RIVER OAKS DR. @ CUMBERLAND BLVD.
A Master Planned Mixed Use Development

REZONING
SITE PLAN
SCALE: 1" = 40'
DATE: November 11, 2016
PROJECT: 9818308

PETITION NO: Z-18

ZONING COMMENTS:

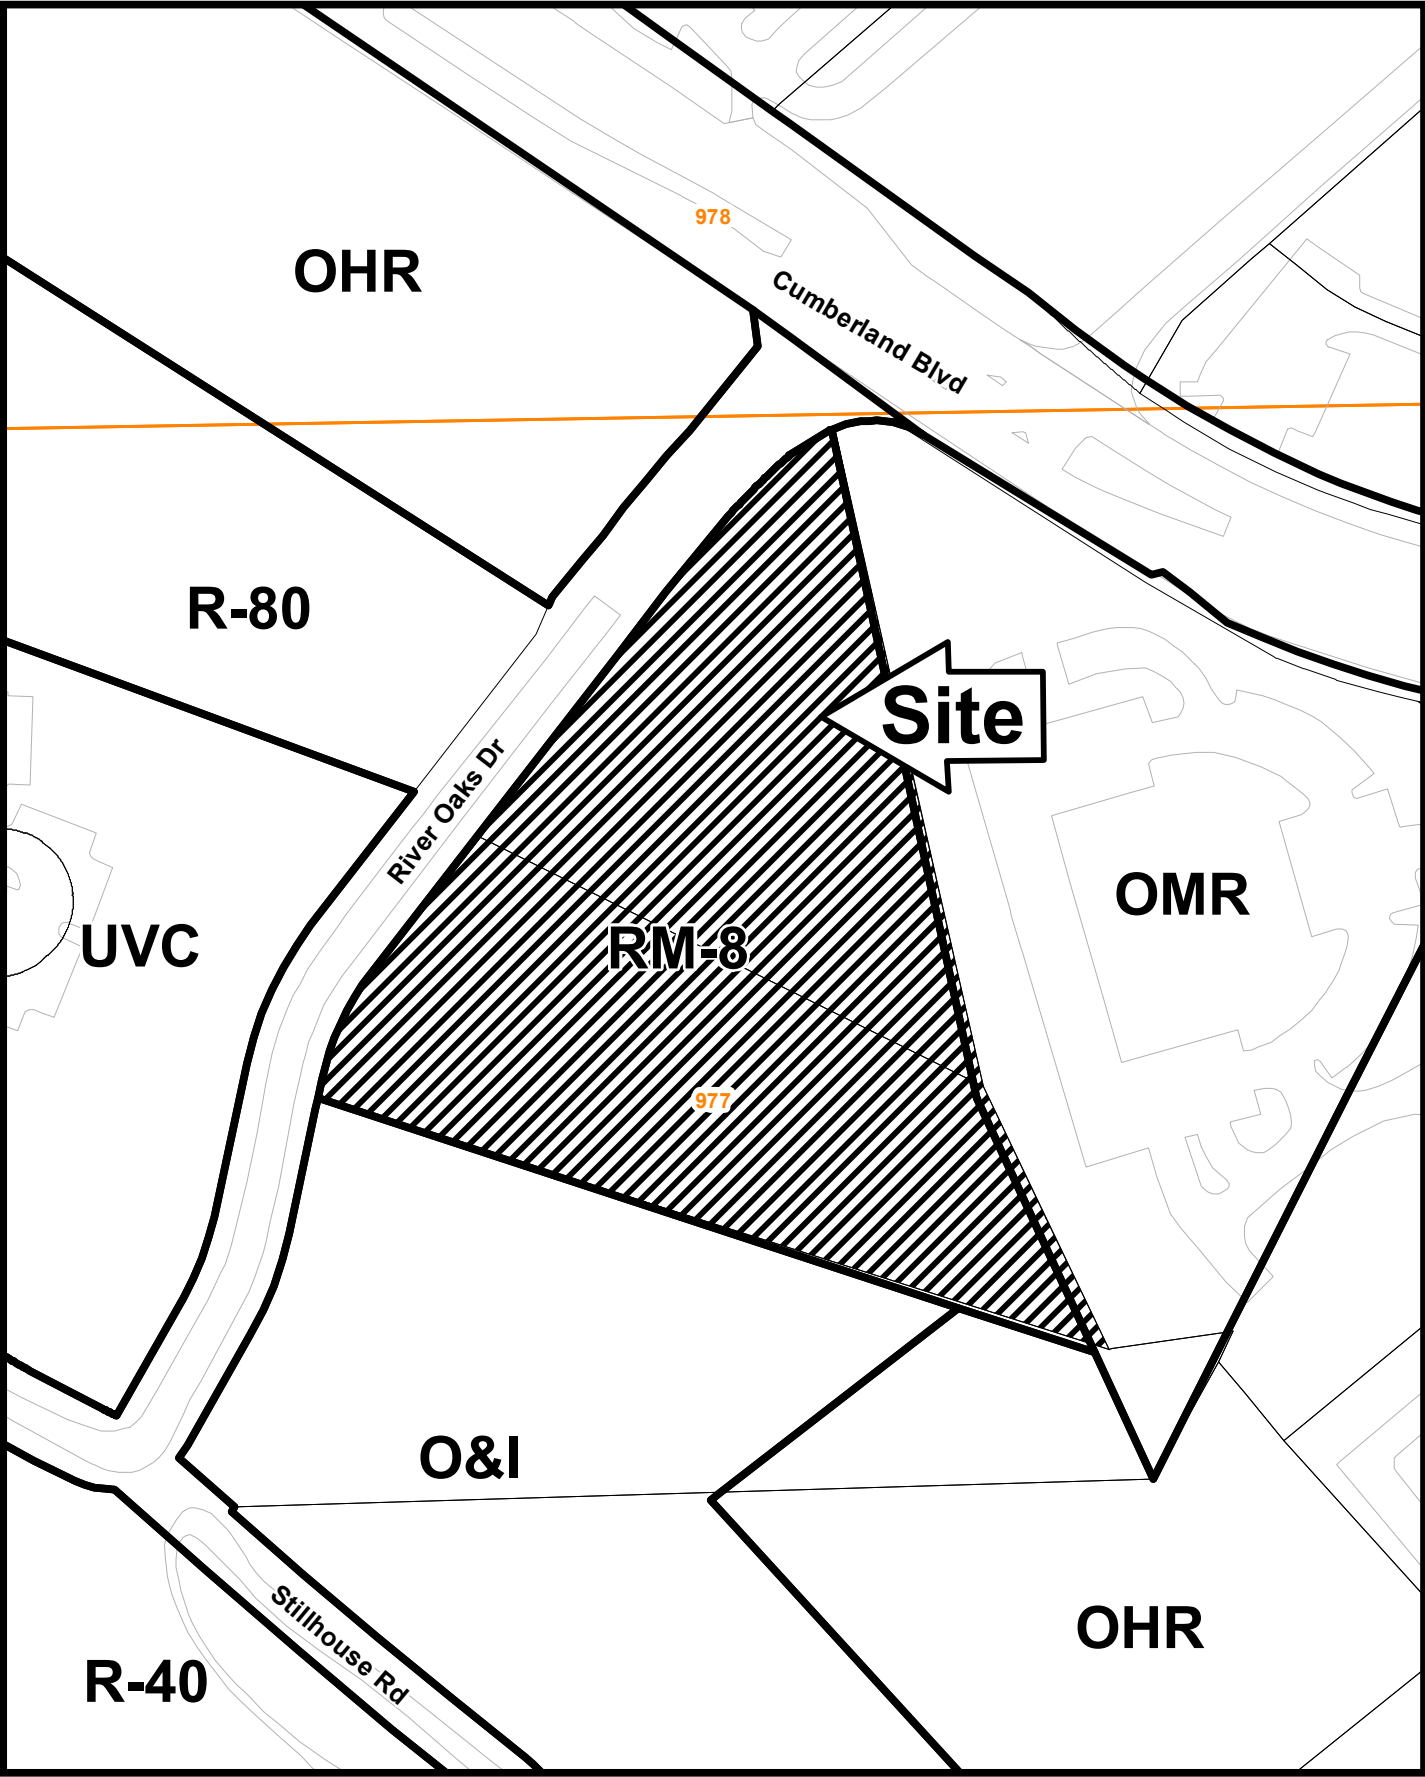
The proposed plan will require contemporaneous variances to: (1) Waive the front setback from 50 feet to 10 feet; and (2) Waive the side setbacks from 30 feet to 20 feet.

1. This site is located to the east of River Oaks Drive just south of Cumberland Boulevard. Average slopes on the site are steep and range from 18 to 40%. The existing site is wooded with a mixture of soft and hardwood species. The majority of the site (2.7 ac) discharges by overland flow to the right-of-way of River Oaks Drive to the west. The remainder of the site (0.5 ac) drains to the southeast corner into the offsite detention facility located on the adjacent City View property.

2. The proposed onsite underground stormwater management facility must account for the existing downstream system capacity. The site design must also account for the conveyance of the existing stormwater discharge from the adjacent 3300 Cumberland Boulevard parcel that traverses the northern corner of the site via a concrete flume to the northern terminus of River Oaks Drive.

3. Due to the steepness of the site terrain, elevated erosion control measures will be required to protect the nearby stream to the south.

The site roadway configuration and retaining wall located in the right-of-way do not meet Cobb DOT standards.

The site roadway configuration and retaining wall do not meet Cobb County DOT standards. Recommend roadway design and retaining wall details to be determined during plan review, subject to Cobb County DOT approval.
